Council Report

To: Council **Date:** October 26, 2017
From: Jonathan Tinney, Director, Sustainable Planning and Community Development
Subject: **Update Report - Development Permit with Variances Application No. 00033 for 1421 Fairfield Road**

To: City of Victoria
 From: Evan Peterson, Barefoot Planning
 Date: September 11, 2017
 Att: Mayor and Council
 Re: 1421 Fairfield Road – Landscaping Revisions

Gye and Associates.ca
PROJECT
1421 Fairfield Road, Victoria, BC
SHEET TITLE
Tree Management Plan-Construction Phase
(for Development Permit App.)
UPDATED

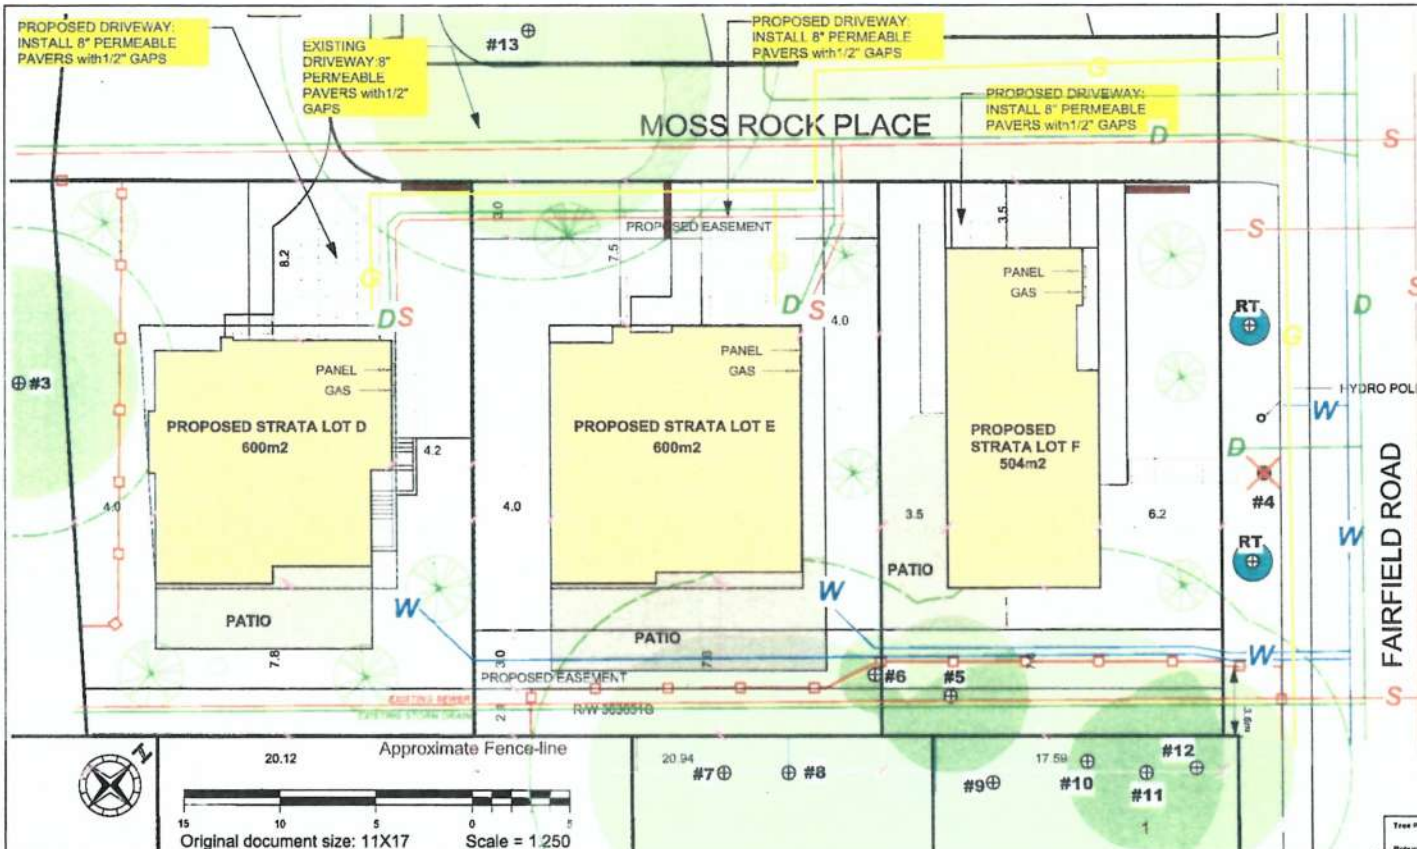
Revised Tree Protection Fencing detail to be constructed with a 2nd frame and accurate. (See photo below). Spacing/fencing will then be affected to the same extent as the original plan. A 2nd frame will be installed, clearly describing the area within as a TREE PROTECTION AREA - TPA.

9. In compensation for removal of the boulevard tree, two replacement trees shall be planted on boulevard as per City of Victoria Tree Protection Bylaw standards.
